ADDENDUM NO. 1

**EDGEMONT SCHOOL DISTRICT
GREENVILLE & SEELY PLACE SCHOOLS
HVAC UPGRADES AND CAFETERIA RENOVATIONS**

DATE: January 24, 2023

This Addendum consists of three (3) Pages, Sketch SK-A1.0, revised drawings GVES M200, GVES E101, SPES MD100, SPES M100, SPES M101, SPES M102, SPES M103, SPES M104, SPES M200, SPES M203, SPES M300, SPES M400, SPES ER100, SPES ER104, SPES E100, SPES E103, and SPES E104.

1-24-2023	ADDENDUM #1
1-06-2023	BID
DATE	ISSUED TO
SHEET SIZE 30"x42"	DRAWING NO. SPES M100
SCALE AS NOTED	FILE NO. 21434.01
DRAWN BY LFG

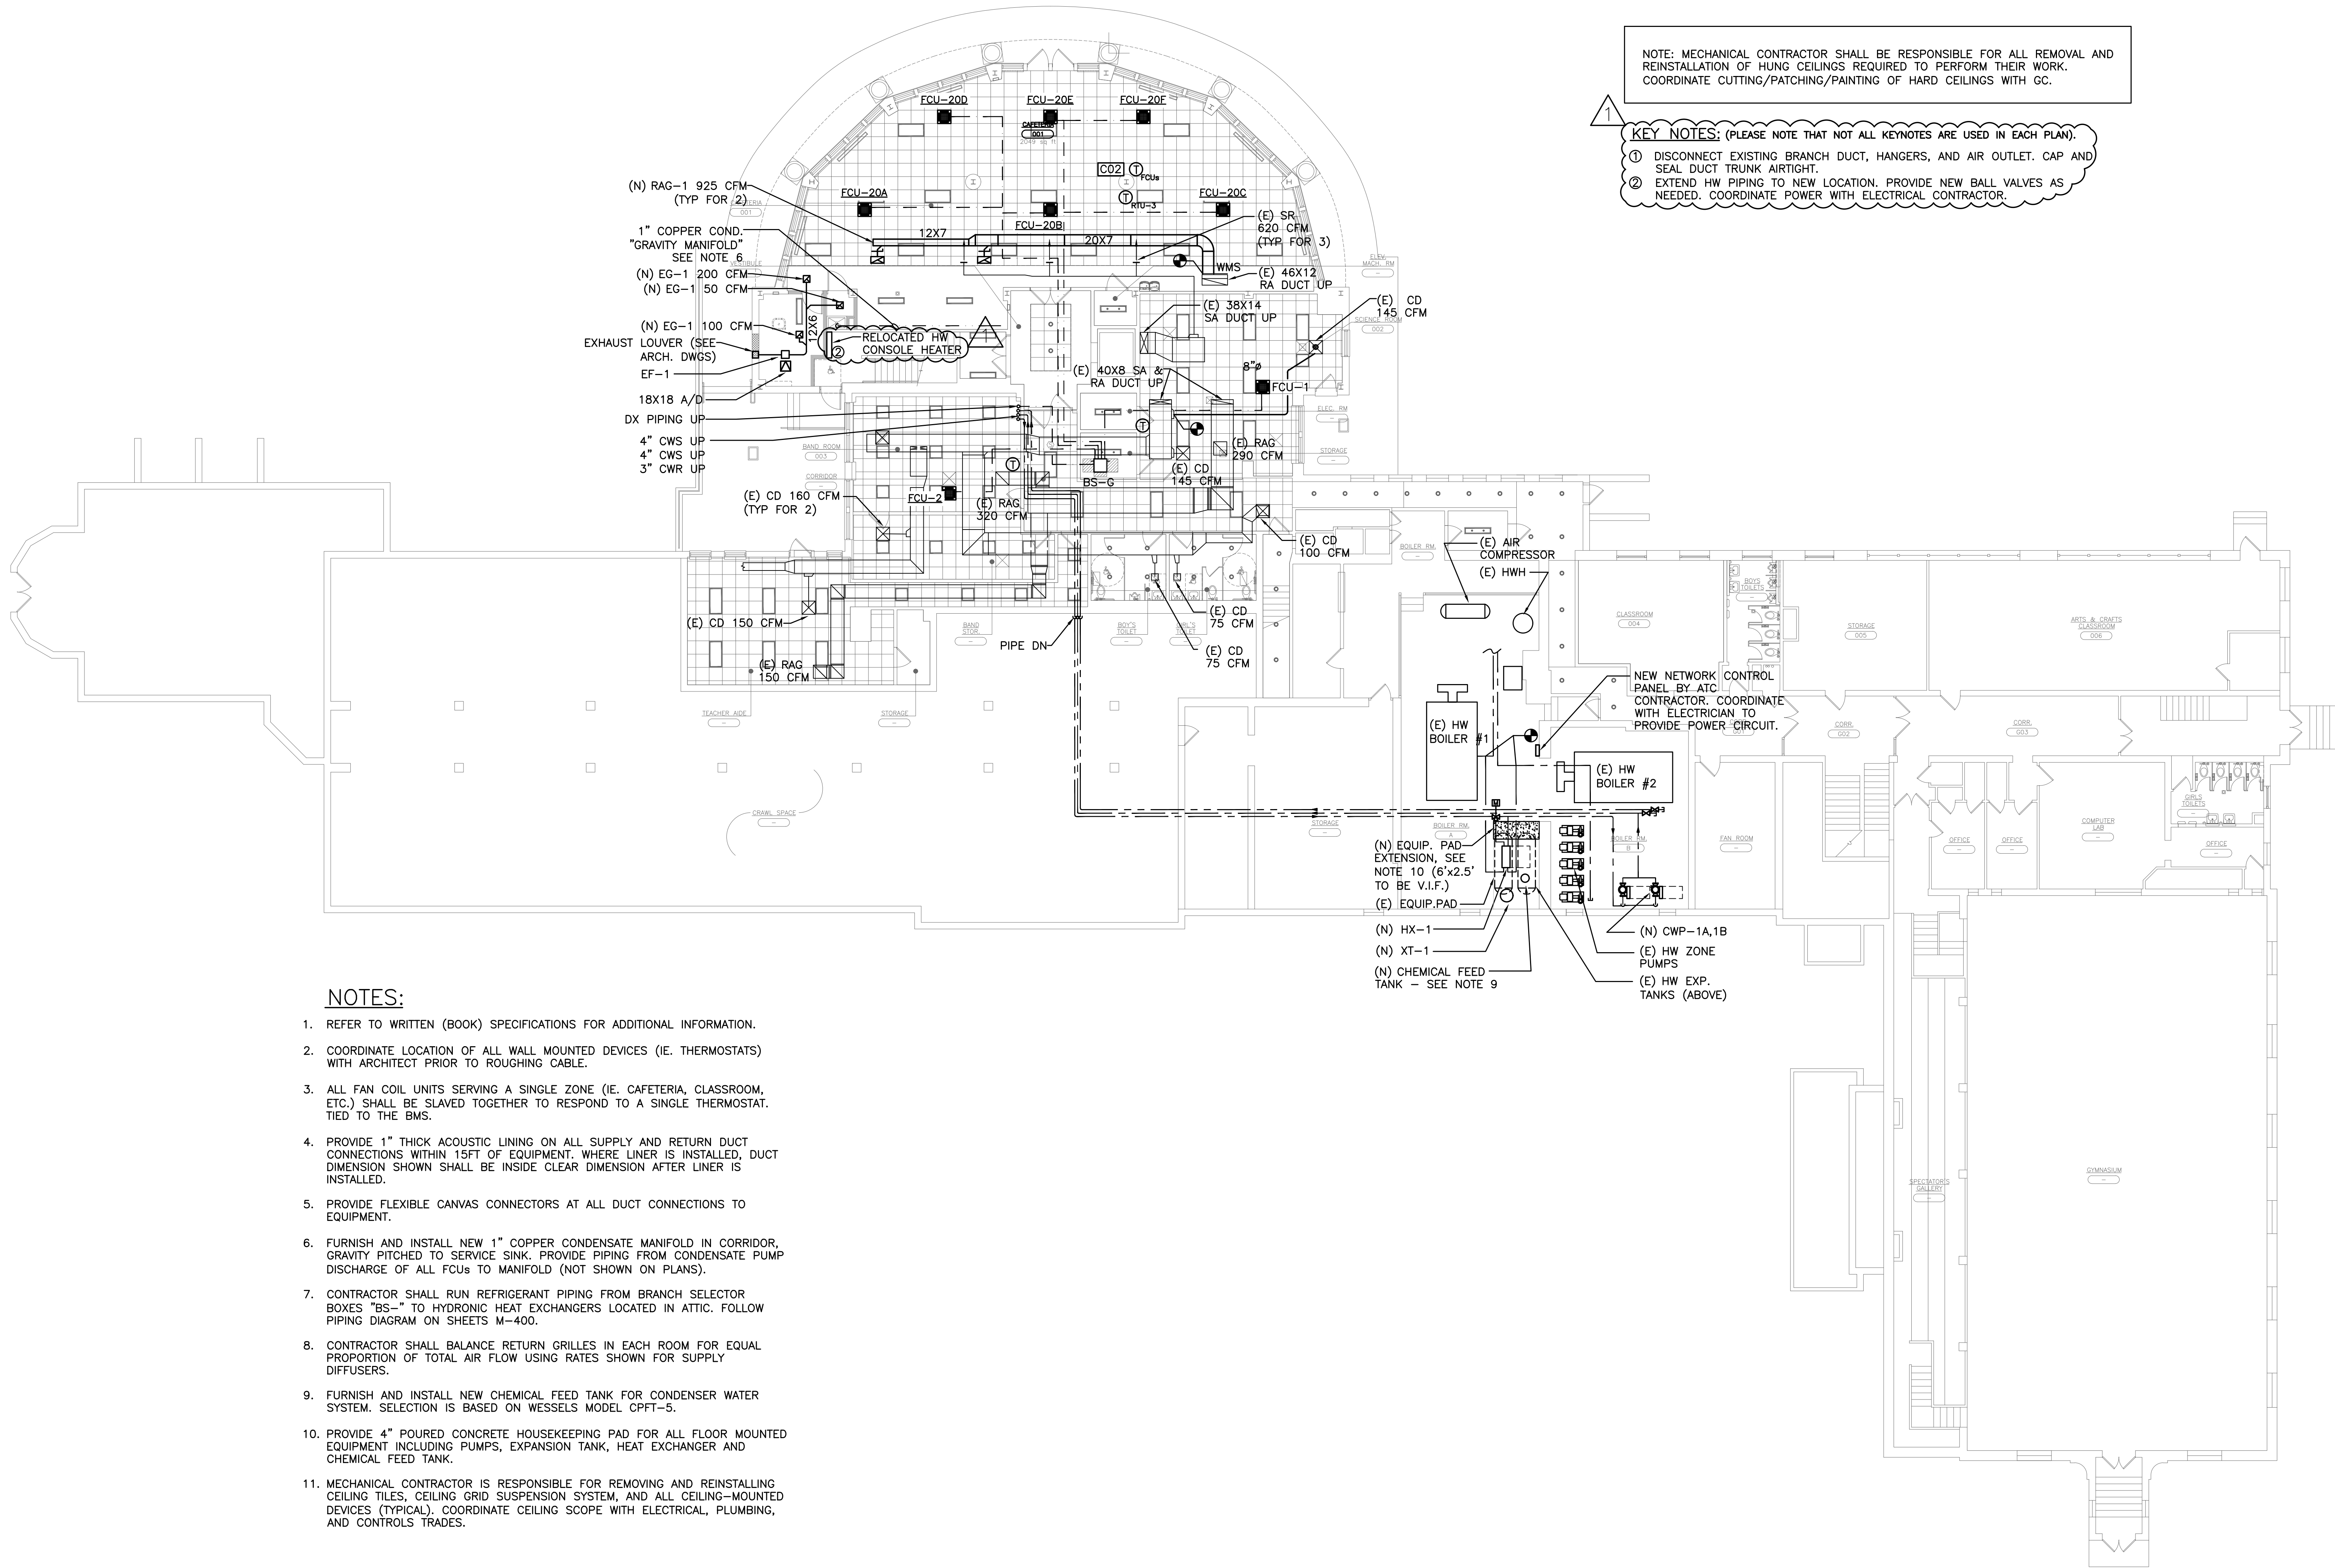
DRAWING SPES M100 – LOWER LEVEL MECHANICAL PLAN

Detail 1, **ADD** Key Notes as shown on drawing attached to this addendum.

- 1 DISCONNECT EXISTING BRANCH DUCT, HANGERS, AND AIR OUTLET. CAP AND SEAL DUCT TRUNK AIRTIGHT.
- 2 EXTEND HW PIPING TO NEW LOCATION. PROVIDE NEW BALL VALVES AS NEEDED. COORDINATE POWER WITH ELECTRICAL CONTRACTOR.

1-24-2023	ADDENDUM #1
1-06-2023	BID
DATE	ISSUED TO
SHEET SIZE 30"x42"	DRAWING NO. SPES M101
SCALE AS NOTED	
DRAWN BY LFG	FILE NO. 21434.0

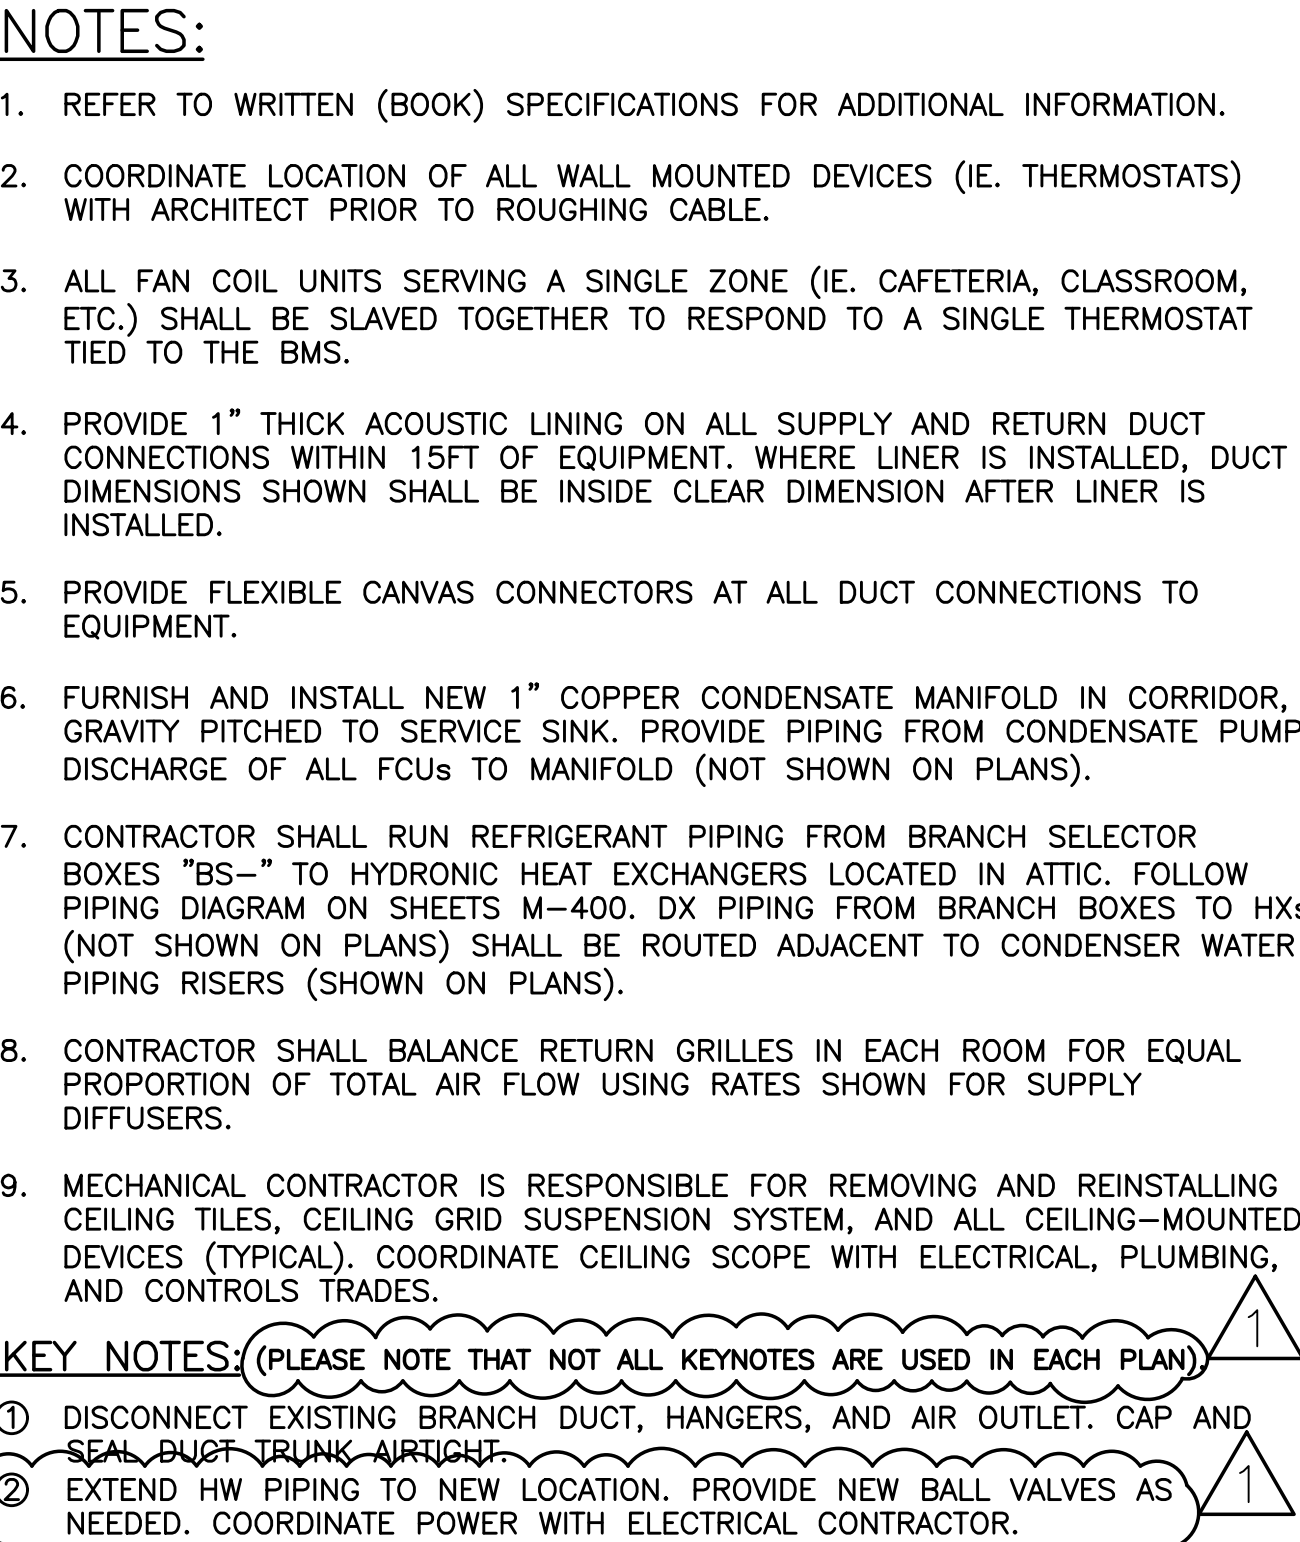
DRAWING SPES M101 – FIRST FLOOR MECHANICAL PLAN

Detail 1, **ADD** Key Note #2 as shown on drawing attached to this addendum.

1-24-2023	ADDENDUM #1
1-06-2023	BID
DATE	ISSUED TO
SHEET SIZE 30"x42"	DRAWING NO. SPES M102
SCALE AS NOTED	FILE NO. 21434.01
DRAWN BY LFG

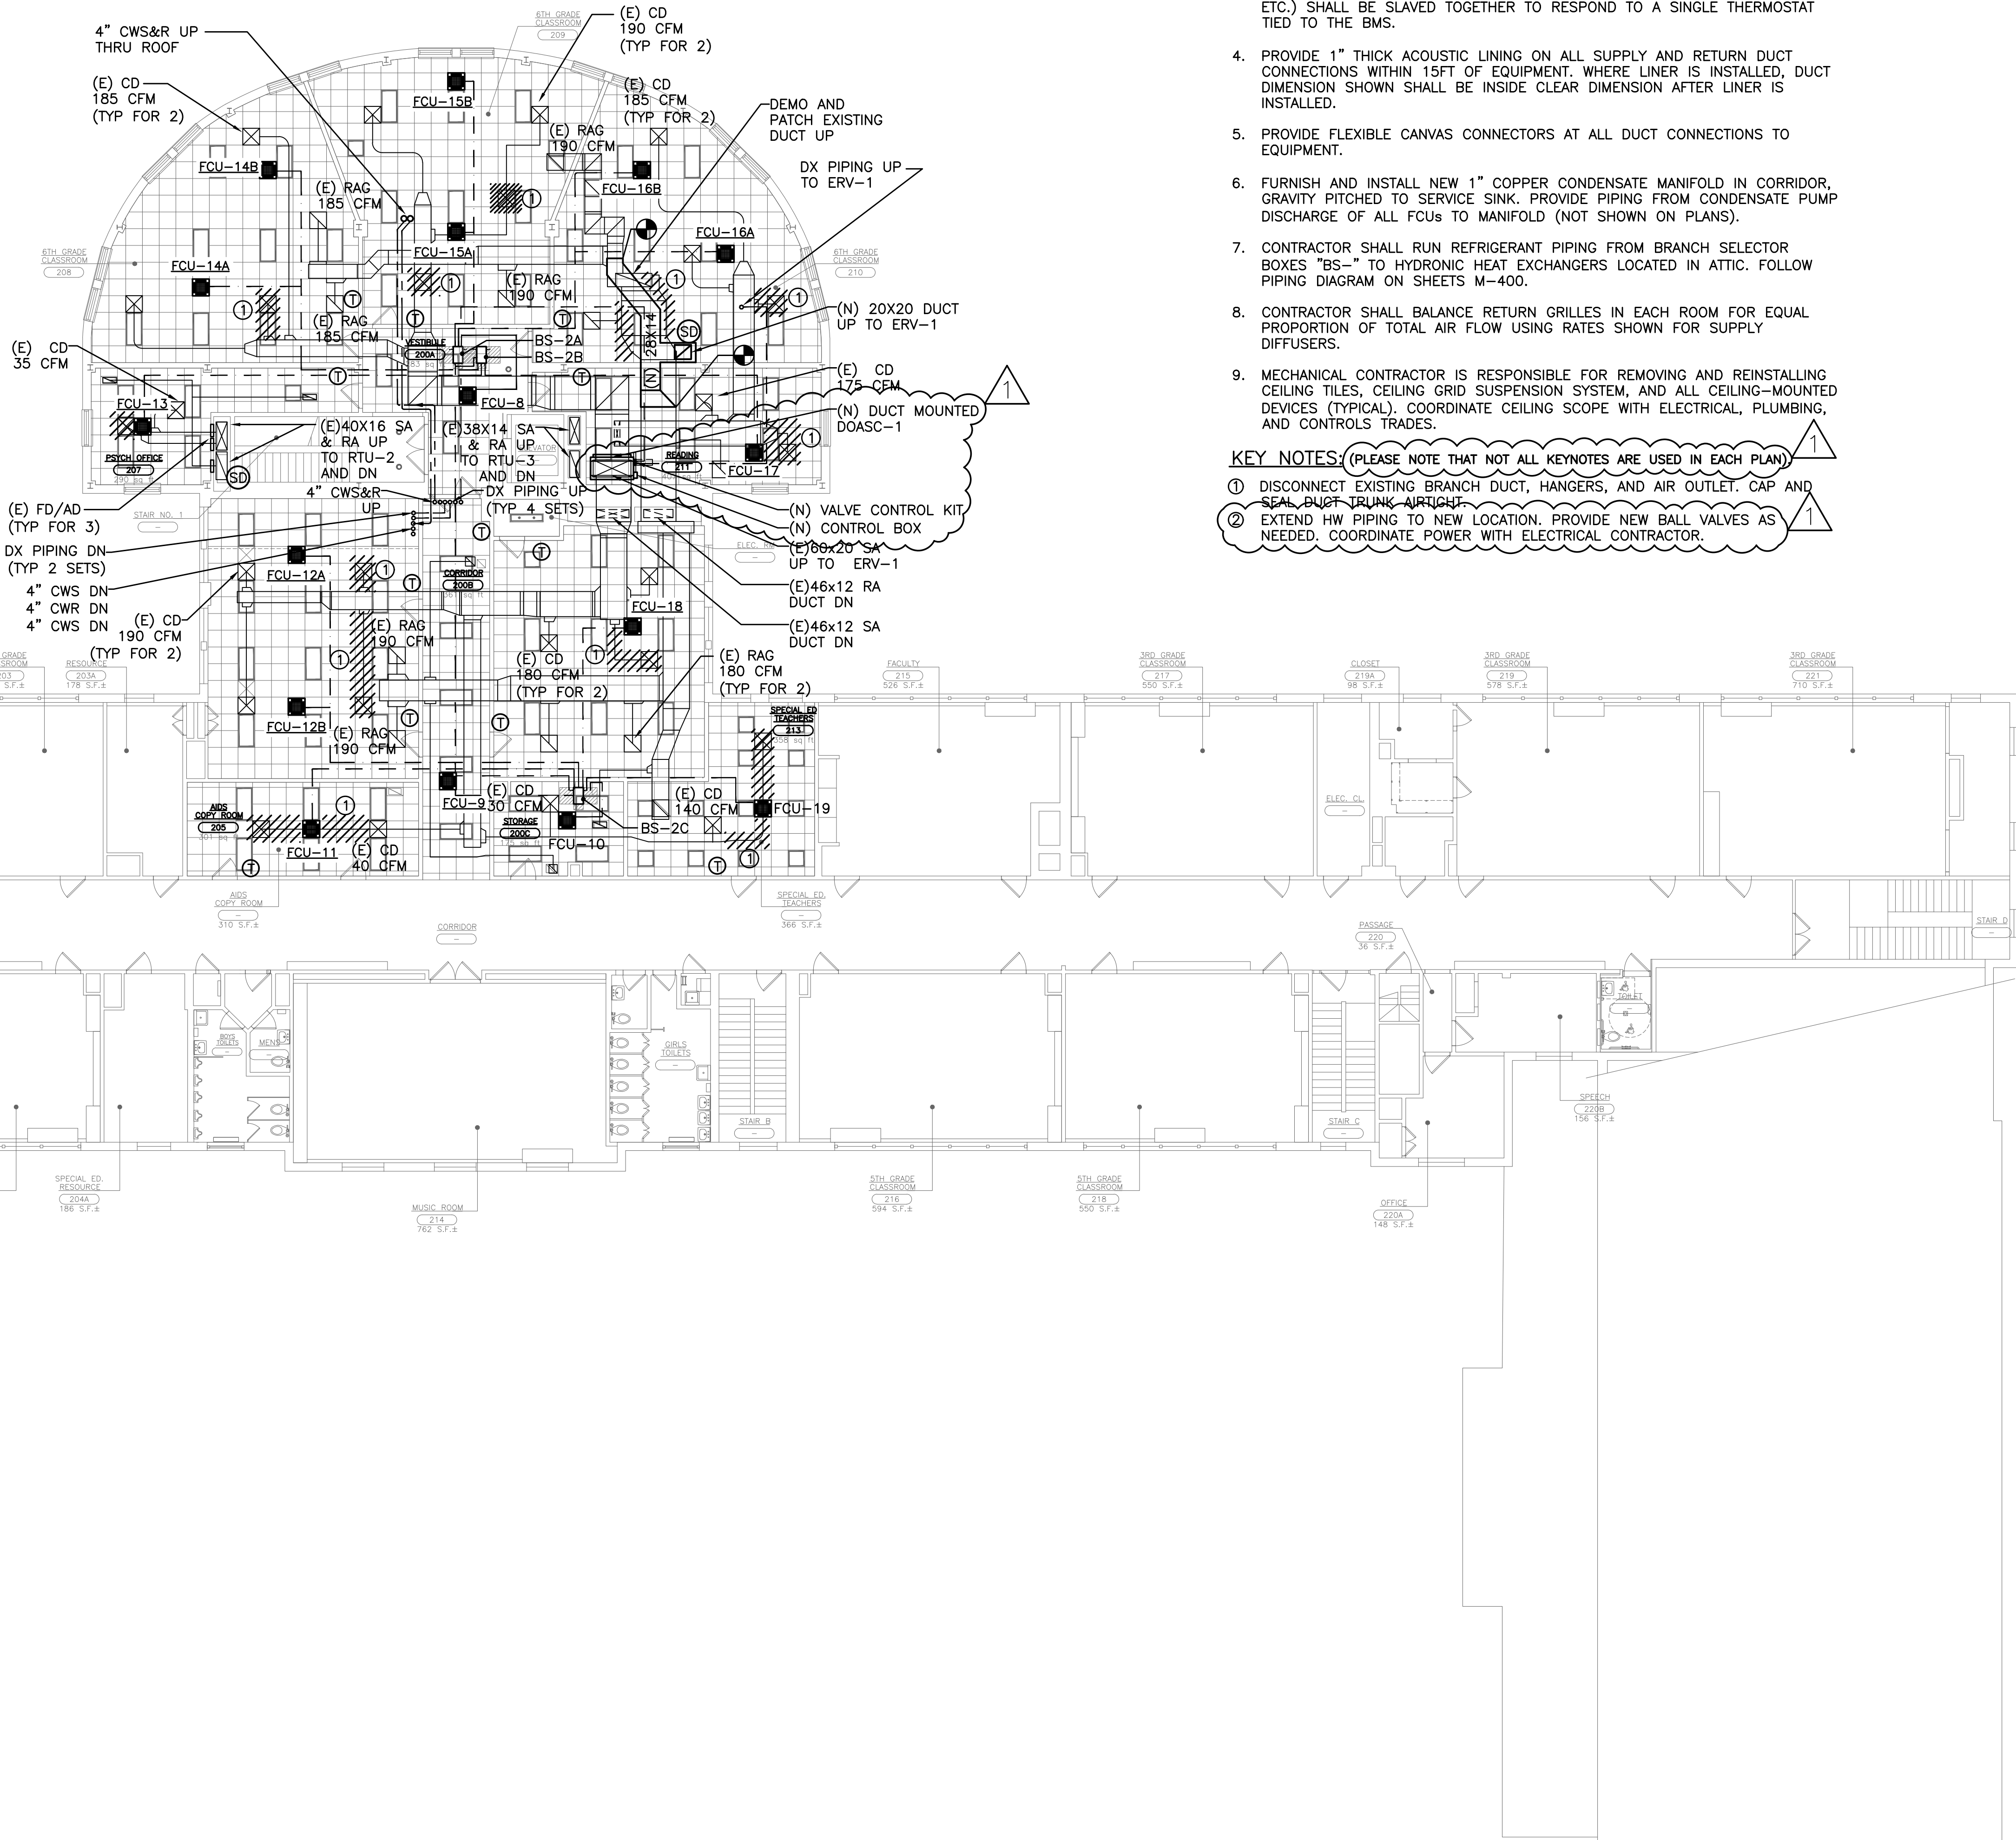
DRAWING SPES M102 – SECOND FLOOR MECHANICAL PLAN

Detail 1, **ADD** notes as shown on drawing attached to this addendum.
